REV-A 5/10/2010

O4 Controller		
Size	Document Number	Rev
D	<Doc>	A
Date:	Thursday, July 15, 2010	Sheet 1 of 1

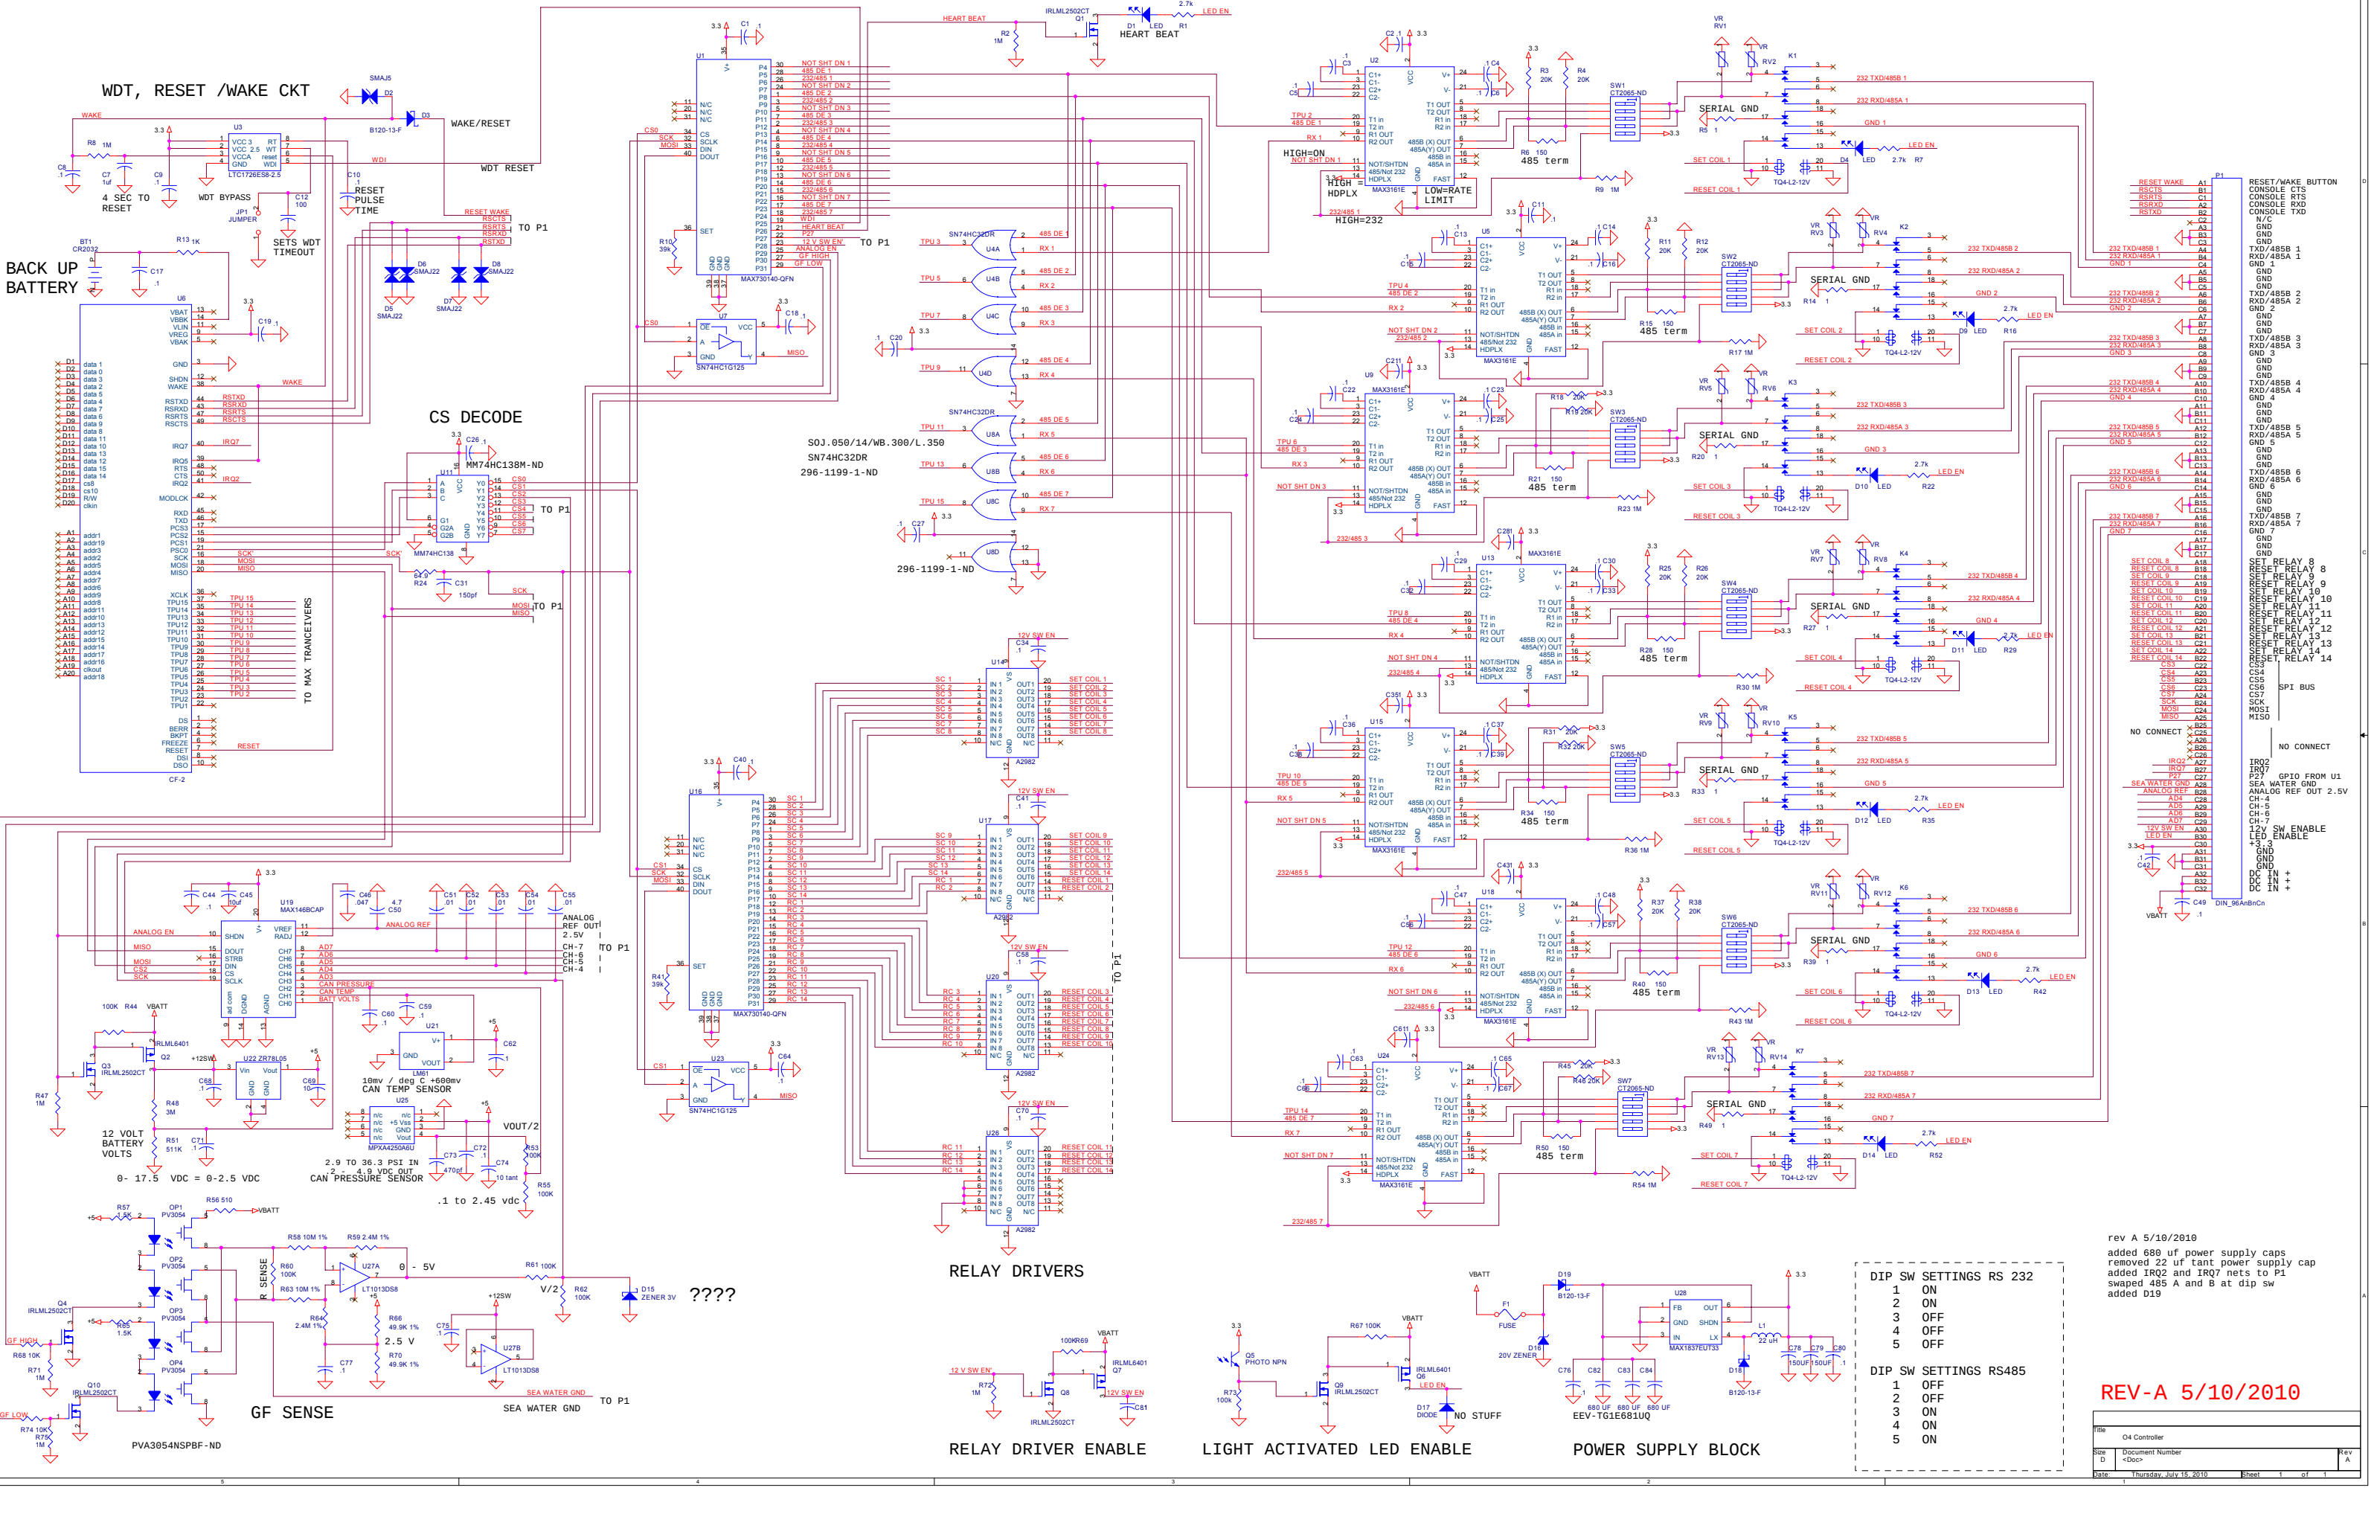
rev A 5/10/2010
added 680 uf power supply caps
removed 22 uf tant power supply cap
added IRQ2 and IRQ7 nets to P1
swapped 485 A and B at dip sw
added D19
